| Make | Model | Year | Install | CAN | Lights | BCM | POC1 | I/O Changes |
|----------|----------|------|---------|-----|-------------|-----|-----------|------------------|
| Infiniti | QX50 PTS | 2019 | Type 2 | BCM | CM I/O | DSD | Hazard1/2 | |

FTI-NSP2 Type 2 - Installation Notes & Wiring Diagram

Overview: The initial production release of the FTI-NSP2 harness has an issue where the POC1 circuit is incorrectly positioned in the CM7 I/O connector. This issue affects only the gray 20-pin CM7 I/O connector illustrated below in figure 1.

Figure 1: Incorrect placement

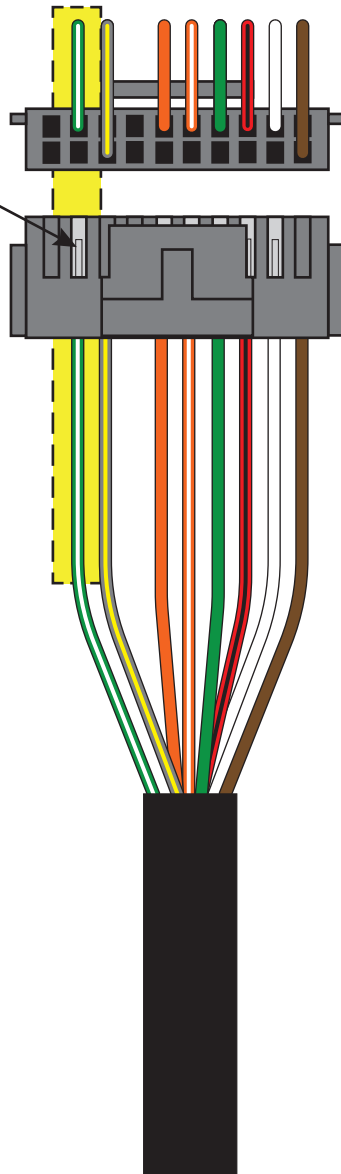
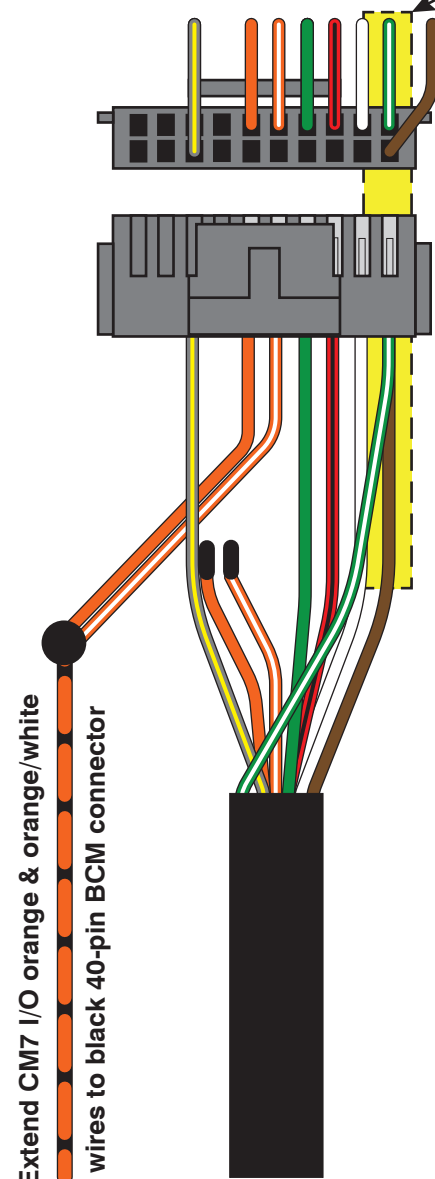
Issue: The green/white parking light circuit is positioned in pin position #17, the fixed light output where the green/white wire is typically placed for parking lights, but the harness solution uses the vehicle hazard lights instead, the result when used as supplied is an erratic light display.

- 1.) Use a pick tool to depress the locking tab on the terminal connector of the green/white wire
- 2.) Remove wire and prepare to reposition
- 3.) Once removed, reposition the locking tab by using a razor knife to lift the tab into a usable position
- 4.) With locking tab repositioned, relocate to pin position #1 (top right position as illustrated)
- 5.) Push the terminal connector into the I/O connector housing until the locking tab clicks into place and the wire is secure
- 6.) Correction complete, you may now complete the installation, but remember to configure POC1 for Hazards (setting #30)
